SEWAGE DISPOSAL SYSTEM

SUBDIVISION Mt. Hebron ROAD 9433 Tiller Drive LOT 20, Sec. 16

# HOWARD COUNTY HEALTH DEPARTMENT

RE: Building Permit Application 63511  
Garage/Carport Extension

# Mound Nelson Lot 20 Notes

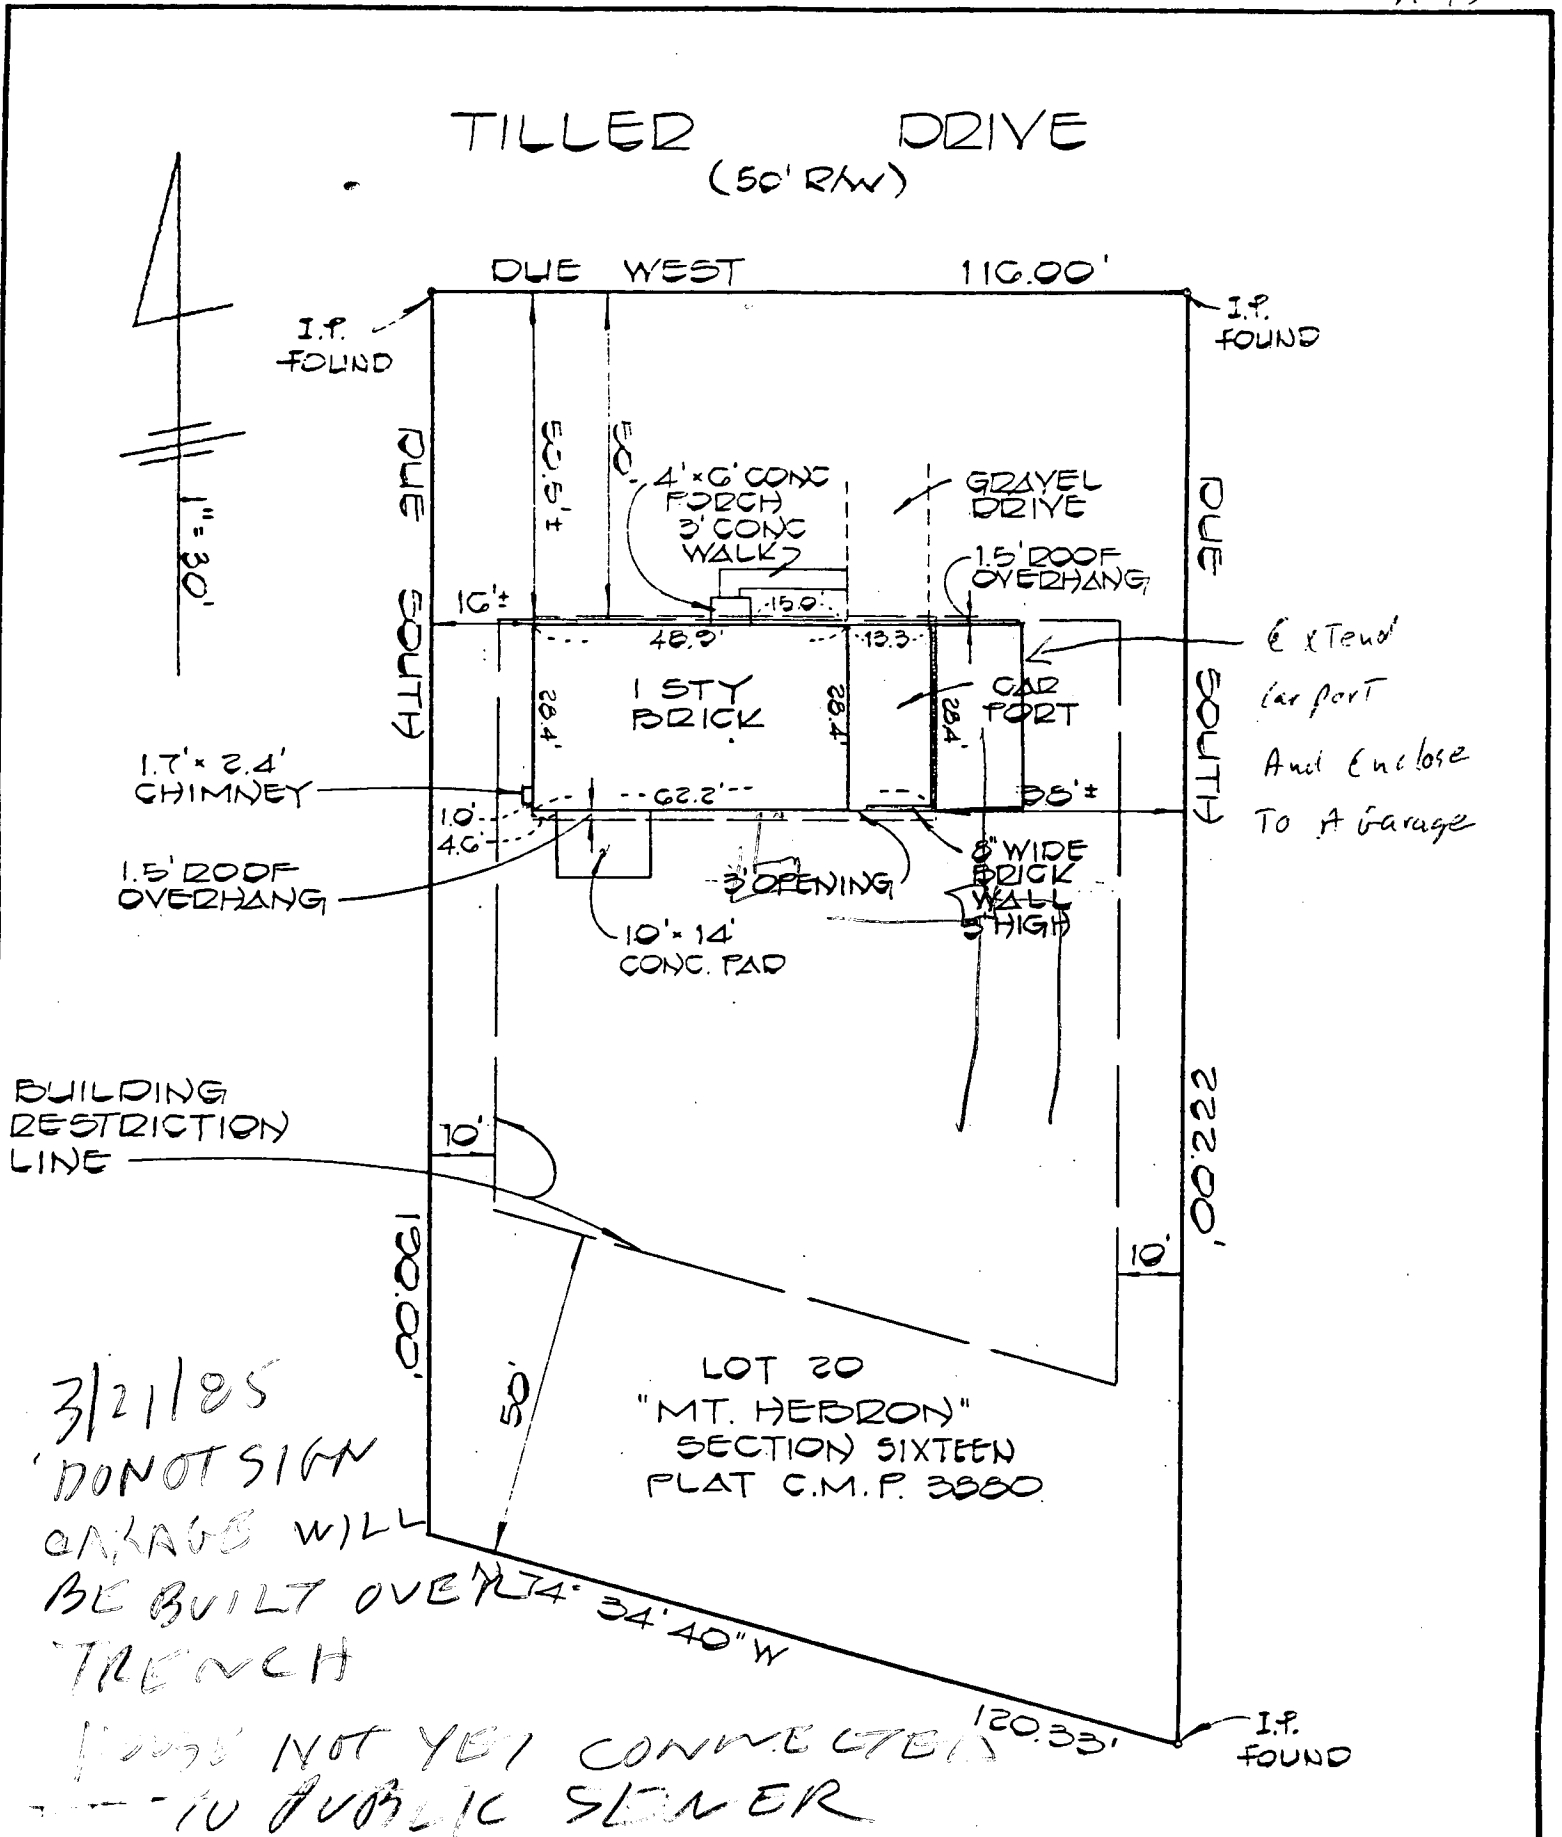
7/17/81 Off. ing. to H. J. Baker re status of this lot.  
Underground drainage pipes have been installed on lot  
to carry surface water down to the creek several  
hundred feet to right of this lot. These pipes are  
apparently ~12 to 14' deep on this lot; any proposed drain  
field must be at least 25 ft removed from these  
underground drainage pipes. Mr. Baker to supply proposed  
location & elevation prior to our site check. Public  
sewer is planned for this area. F. S.

① S 2' 9:26 9:51 9:59  
D 9'

② ⑤ 2' 9:48 9:50 9:54  
D 10'

③ S 2' 9:51 9:56 10:03  
D 11' some soft sand stone in bottom

④ S 2' 9:58 10:00 10:04

D 11' water 10:12

5 S 2' 10:06 10:14 10:30

D 11' water 10:41
